BUREAU OF ENGINEERING
DEPARTMENT OF PUBLIC WORKS
CITY AND COUNTY OF SAN FRANCISCO

CONTRACT 58
 NEW TRAFFIC SIGNALS
DOUGLASS AND MARKET STREETS
TRAFFIC SIGNAL WORK AND
POLE & EQUIPMENT SCHEDULE

SPECIFICATION NO.	1387J
DRAWING NO.	E-3.0
FILE NO.	87,617
REV. NO.	0

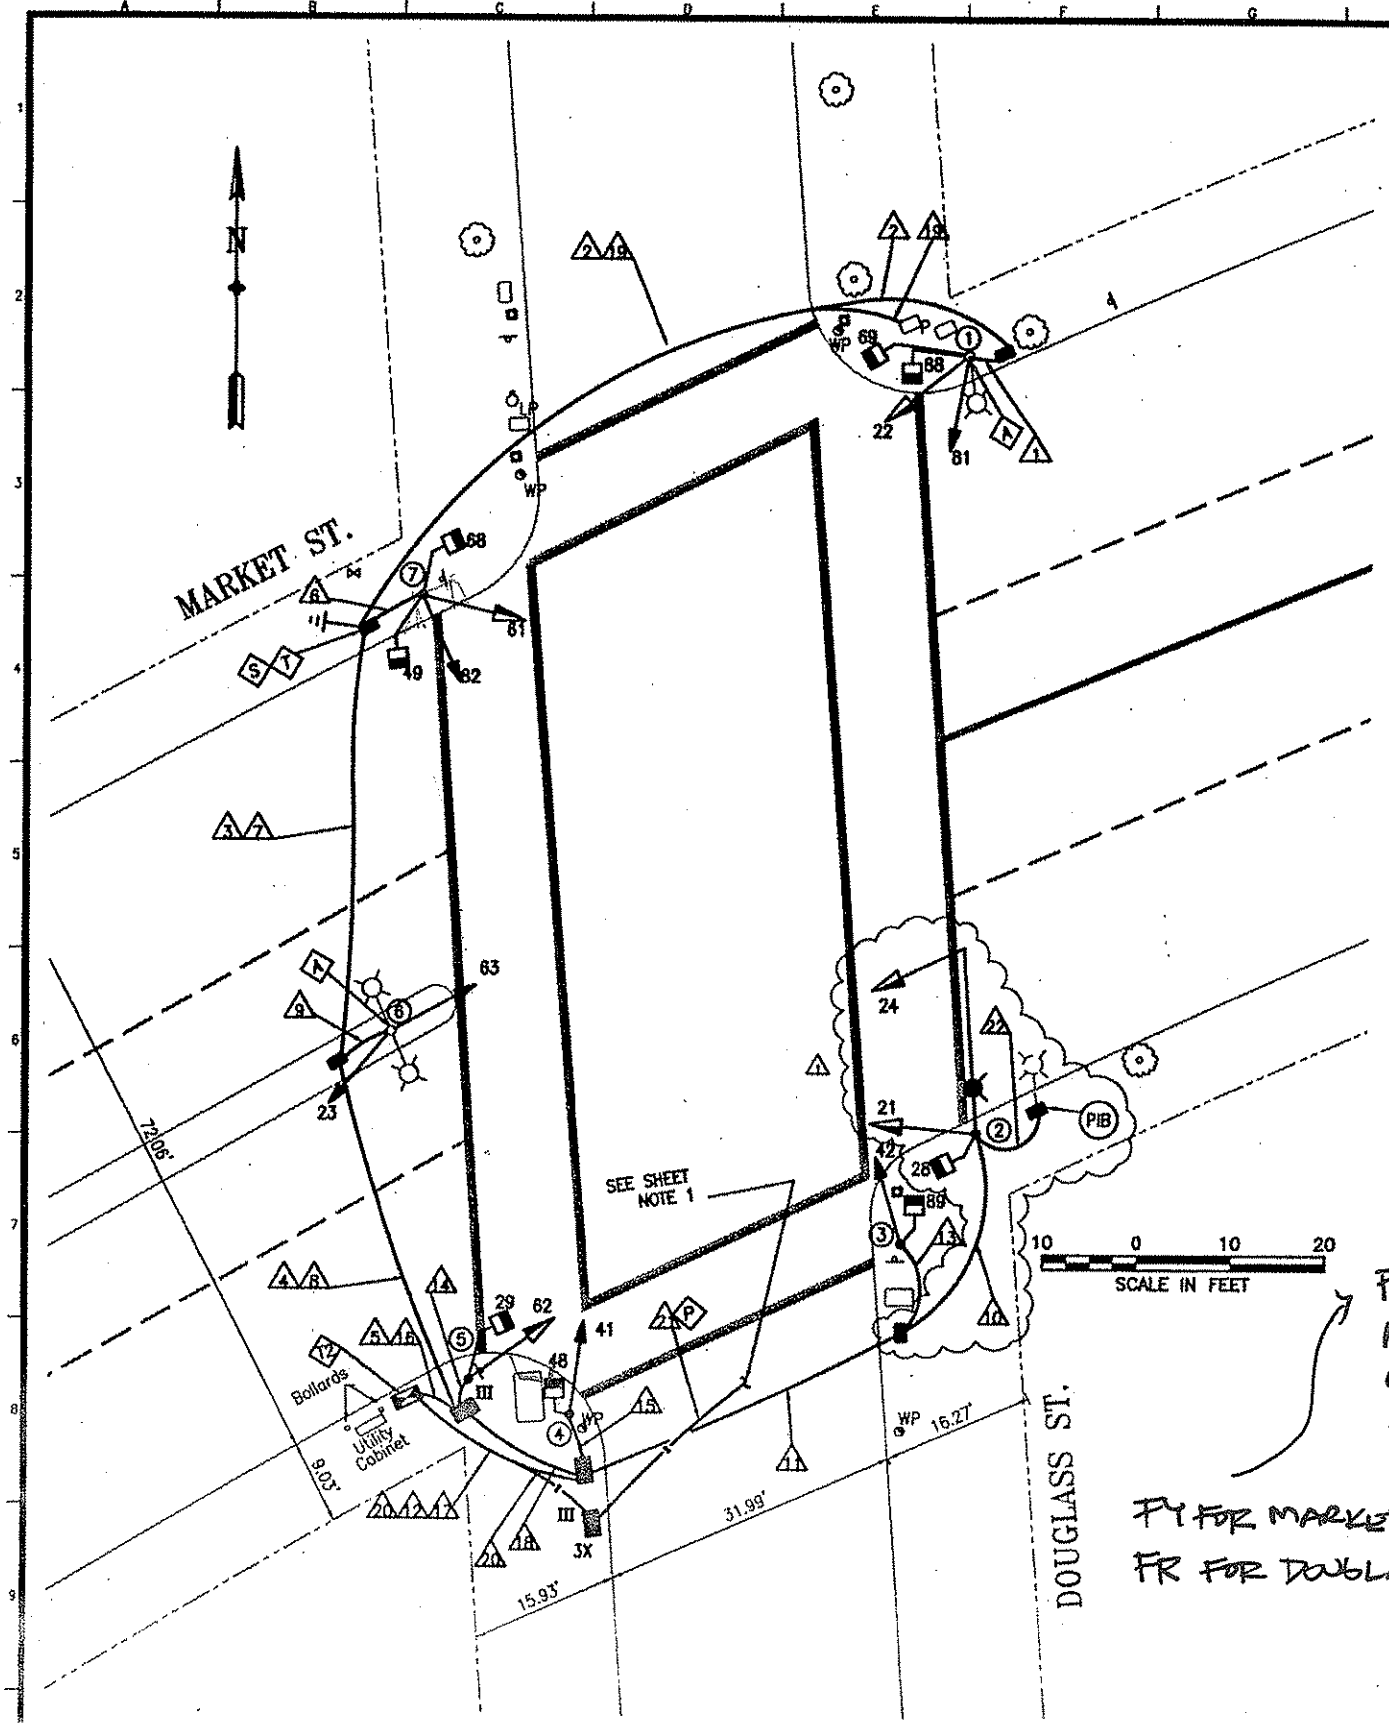
FLASHING OPERATIONS ON 12/17/08 AT 10:50 AM.
 ATTENDED BY: LIDDIE TSUI (TE), FERRI LUMBAD (SIGNAL SHOP), TIM WOULDEN, DAVID LAU (PHOENIX), AND WILSON LEU (PHOENIX)
PHASE DIAGRAM

3-COLOR ACTIVATION ON 12/19/08 AT 9:32 AM
 ATTENDED BY: GERARDINE DE LEON (TE) + FERRI LUMBAD (SIGNAL SHOP)

PT FOR MARKET,
 FR FOR DOUGLASS
